Access Compliance Report

Public Rights-of-Way (Curb Ramps)

Intersection ID: 23917	Main Street: BOSHAM_LN	Cross Street: WHITWORTH_WY	Location: NW
ADA ID: 0DEC53A80ACE	Ramp Type: Perp	Initial Pass/Fail: Fail	Overall Compliance: No
		Severity Score: 22.5

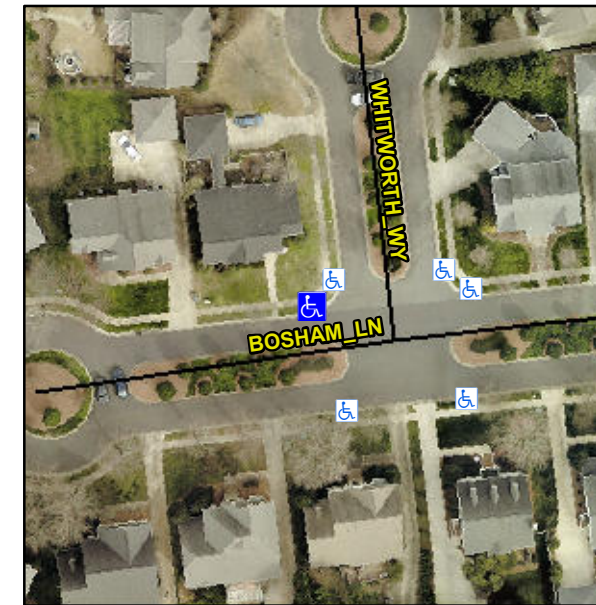
Not Found, R304.5.1, R304.2.2, R304.5.3

Compliance	Description	Data	Compliance	Description	Data
N/A	Ramp Length (in)	46.0	No	Ramp Slope (%)	8.9
No	Ramp Width (in)	40.0	No	Ramp XSlope (%)	3.6
N/A	Flare Type LT	N/A	N/A	Flare Type RT	N/A
N/A	Flare Slope LT (%)	N/A	N/A	Flare Slope RT (%)	N/A
N/A	Flare Traversable LT?	N/A	N/A	Flare Traversable RT?	N/A
N/A	Landing Length (in)	N/A	N/A	DWS Provided?	N/A
N/A	Landing Width (in)	N/A	N/A	DWS Contrast?	N/A
N/A	Landing Slope (%)	N/A	N/A	DWS Length (in)	N/A
N/A	Landing X Slope (%)	N/A	N/A	DWS Full Width?	N/A
N/A	Landing Curb? (Y/N)	N/A	N/A	DWS Offset (in)	N/A
N/A	Shared Landing?	N/A			
N/A	Gutter Ponding?	N/A	N/A	Gutter Slope (%)	N/A
N/A	Gutter Lip Ht (in)	N/A	N/A	Gutter X Slope (%)	N/A
N/A	Painted X Walk1?	No	N/A	Painted X Walk2?	N/A
	X Walk 1 Direction	To S		X Walk 2 Direction	N/A
N/A	X Walk 1 Width (in)	N/A	N/A	X Walk 2 Width (in)	N/A
	X Walk 1 Slope (%)	4.5		X Walk 2 Slope (%)	N/A
	X Walk 1 X Slope (%)	3.1		X Walk 2 X Slope (%)	N/A

Remove & Replace Entire Ramp.
